<b>Well Name:</b> NASH UNIT	<b>Well Location:</b> T23S / R29E / SEC 13 / SWNW / 32.3078485 / -103.9435731	<b>County or Parish/State:</b> EDDY / NM
<b>Well Number:</b> 23	<b>Type of Well:</b> OIL WELL	<b>Allottee or Tribe Name:</b>
<b>Lease Number:</b> NMNM0556859	<b>Unit or CA Name:</b> NASH DRAW - DELAWARE	<b>Unit or CA Number:</b> NMNM70992C
<b>US Well Number:</b> 3001528272	<b>Operator:</b> XTO ENERGY INCORPORATED

**Notice of Intent**

**Type of Action:** Plug and Abandonment

PLUG AND ABANDON WELLBORE  
NASH UNIT 023  
EDDY COUNTY, NEW MEXICO  
Class II

# Nash 023 - Proposed WBD

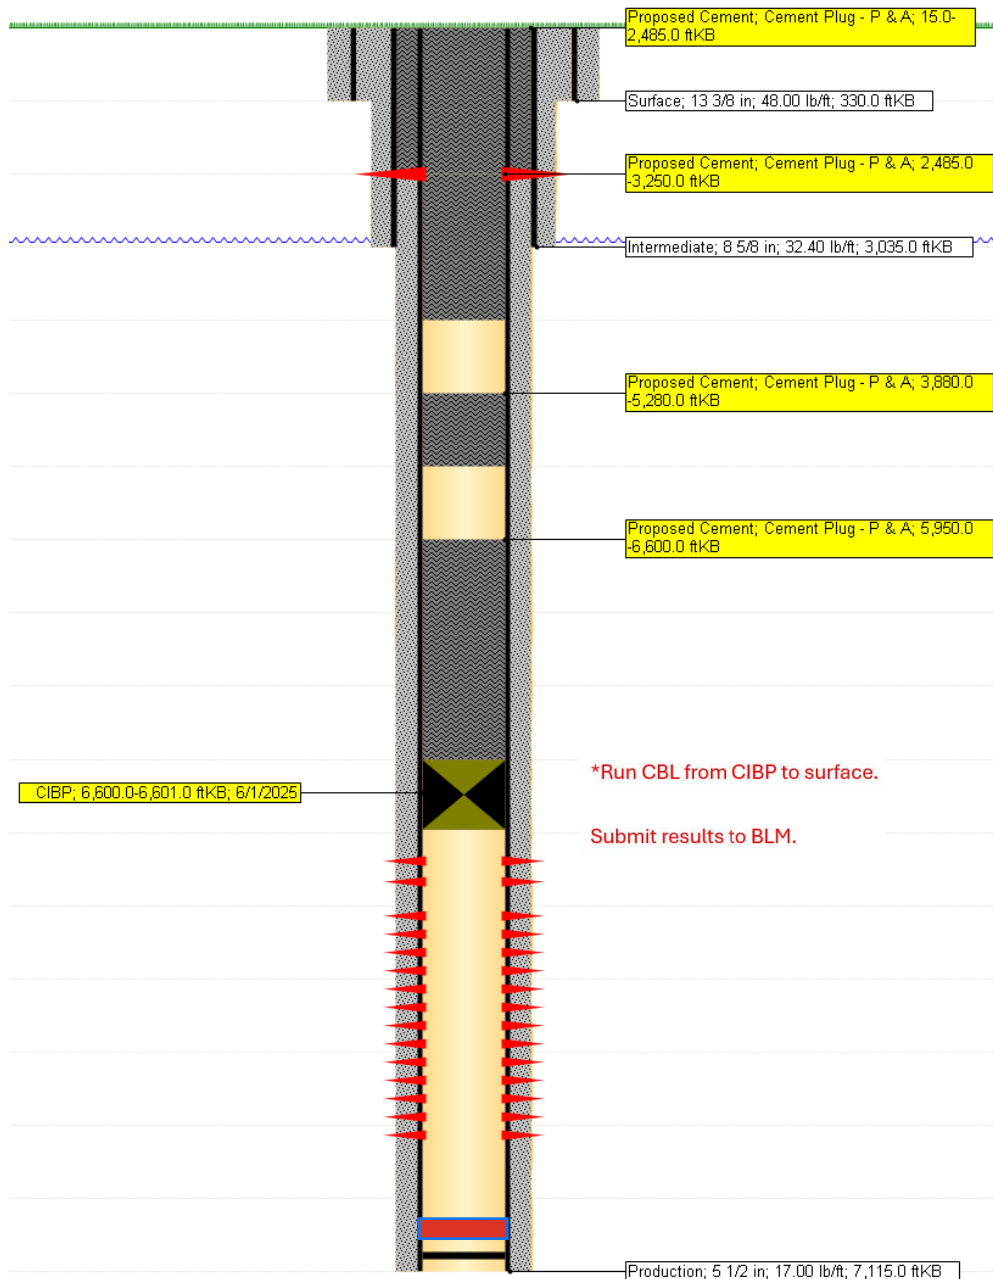
Spot 85 SKS **Class C** atop CIBP: 6,600' to 5939'. PT CIBP to 500 PSIG for 30 min. WOC and Tag.

\*Run CBL from CIBP to surface.  
Submit results to BLM.

TIH with gauge ring and tag PBTD. Spot cement from 6890' to 6721'. WOC and Tag. 25 sxs Class C.

**REVISED**
